Southern Nuclear Operating Company
the southern electric system

August 29, 1996

Joseph M. Farley Nuclear Plant
Generic Letter 96-04 Boraflex Degradation in Spent Fuel Pool Storage Racks

Farley Nuclear Plant
Spent Fuel Pool Silica Graph

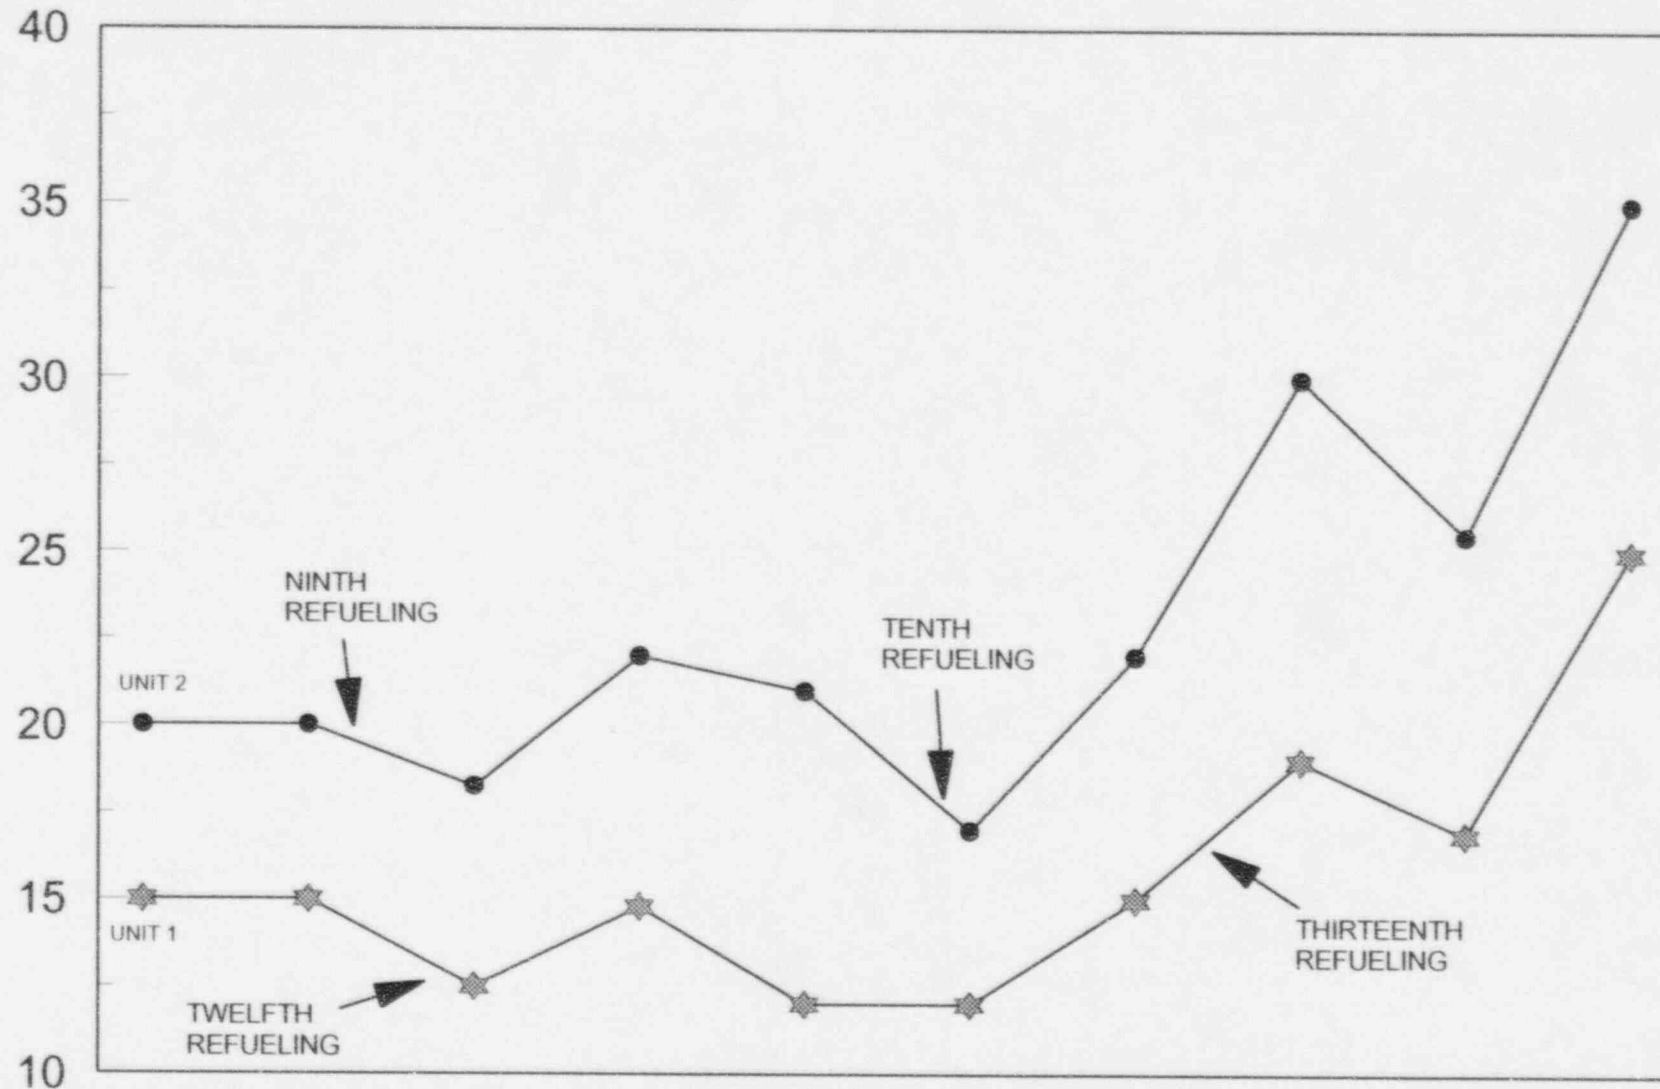
(4) 'Chronological trends of pool reactive silica levels, along with the timing of significant events such as refuelings, pool silica cleanups, etc., should be provided.

Implications of how these pool silica levels relate to Boraflex performance should be described.'

Attachment 1 provides Spent Fuel Pool silica data for Farley Nuclear Plant Units 1 and 2.

SNC does not believe that accurate correlations can be made as to the actual amount of Boraflex degradation that has occurred relative to Silica content of the pool. However, increasing Silica does indicate that some degradation of Boraflex has occurred in the Farley Nuclear Plant spent fuel pools.
